## Planning Assessment Report

### Application to Modify the Minister's Approval for the University of Technology (UTS) Broadway Concept Plan

#### Major Project MP 08\_0116 MOD 1

*Figure 1 – Location of Proposed Excavation*

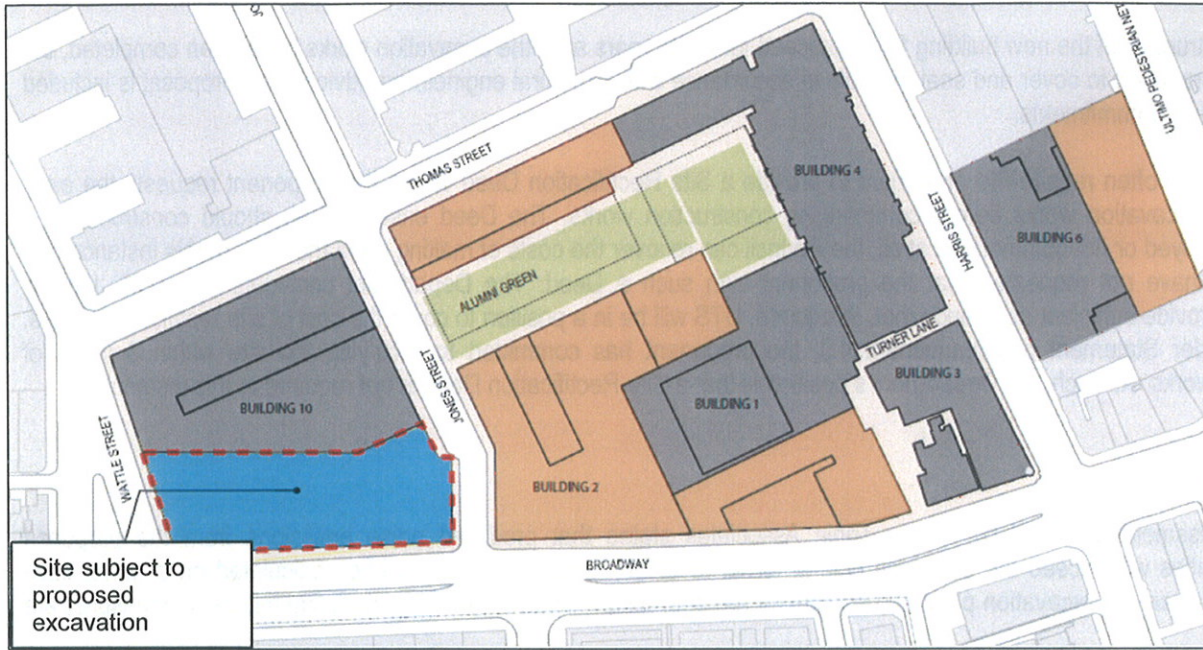
The proposed bulk earthworks are generally in the same location as the approved footprint of the Broadway Building envelope. Refer to Figure 1 below:

*Figure 2 – Extent of Excavation (along the Broadway frontage)*

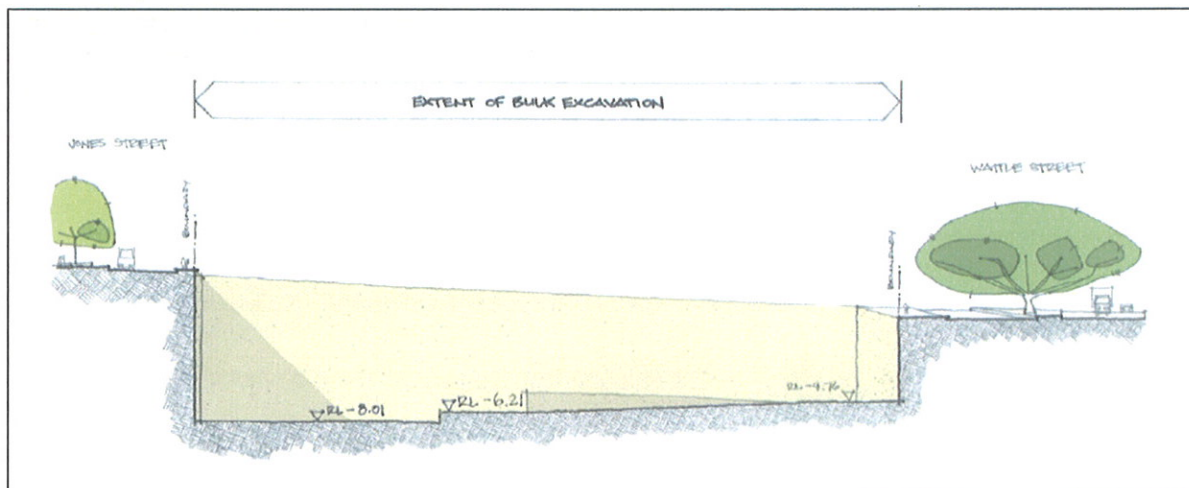
The proposed excavation will provide for four basement levels, requiring excavation to a depth of RL -8.01 at Jones St, RL -6.21 at the centre of the site and RL -4.76 at Wattle Street.

It is considered that the extent of the excavation, in terms of depths and the proportion of the Broadway Building site subject to the works, is consistent with the approved Concept Plan.
